## SB, Hydraulic motor studs snap off, CRT 60, 2024-03

Fig. 2 - 4: Check if there is a gap between the hydraulic motor flange and the stub shaft.

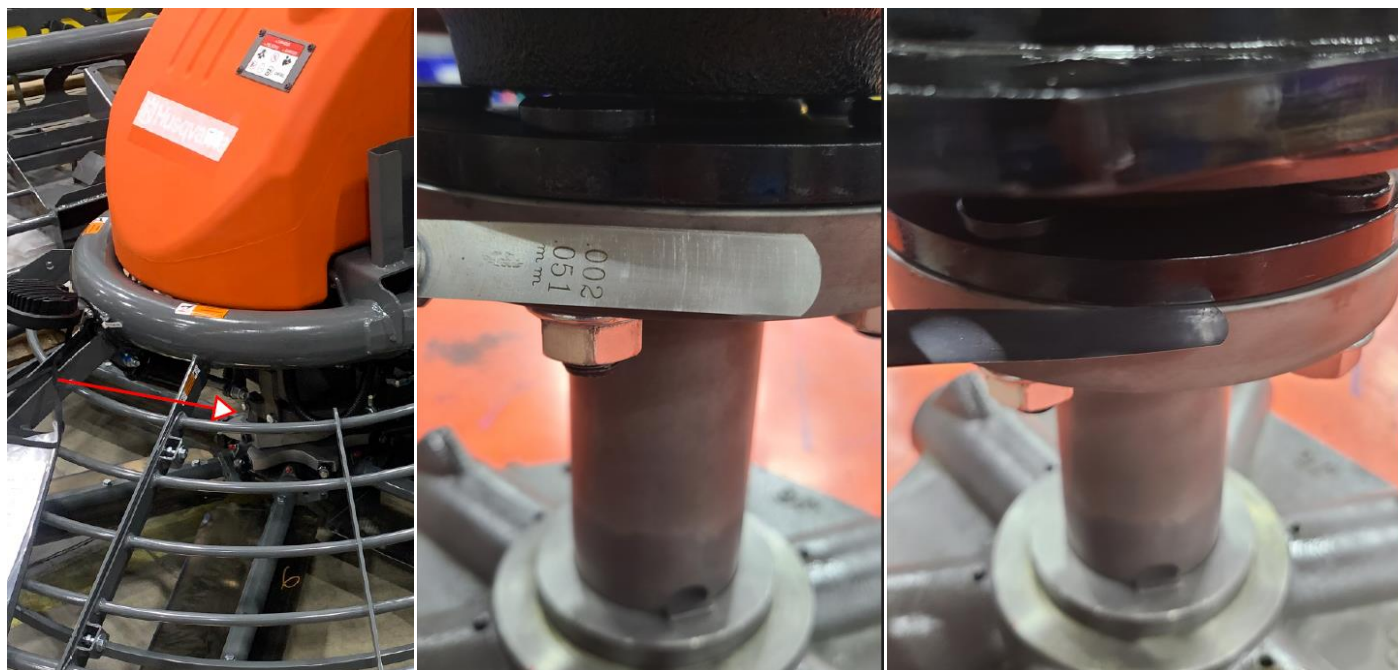
Check if there is a gap between the hydraulic motor flange and the stub shaft on both sides of the machine. Try to insert the thinnest feeler gauge from the set between the hydraulic motor flange and the stub shaft (figures 2 – 4).

Try at several points along the diameter of the flange.

The gauge should not enter between the parts.

If the gauge is possible to insert, then change or modify the shaft 599062901.

Fig. 5: Use a 60° countersink drill bit to make diameter equal or slightly bigger than 19.85 mm.

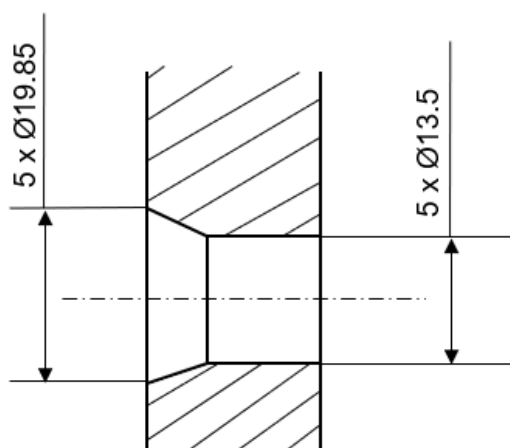
Modification should be done by using 60° countersink drill bit until each hole diameter is equal or slightly bigger than 19.85 mm, see figure 5.

Fig. 6: Revision A, old revision with straight holes.

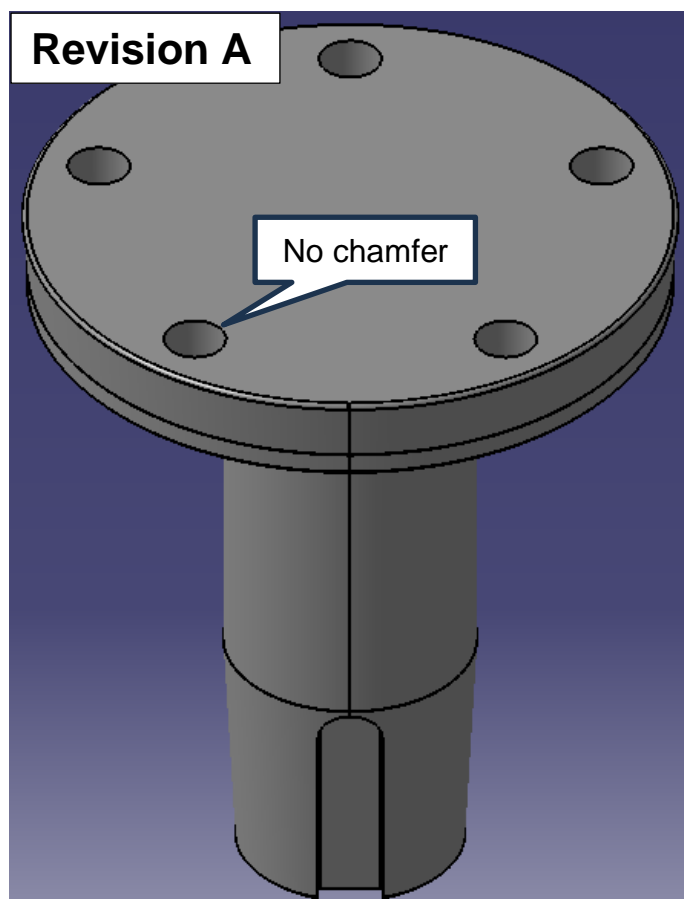
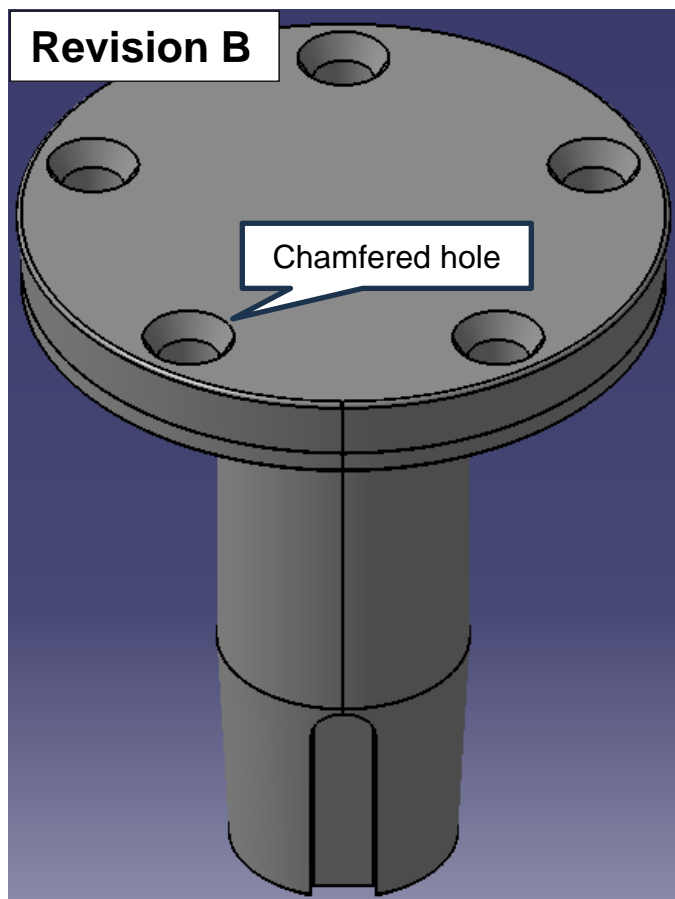
A new revision of stub shaft 599062901 with chamfered holes is introduced.

Check the local stock, all parts of revision A (figure 6) should be scrapped or modified.

Fig. 7: Revision B, new revision with chamfered holes.
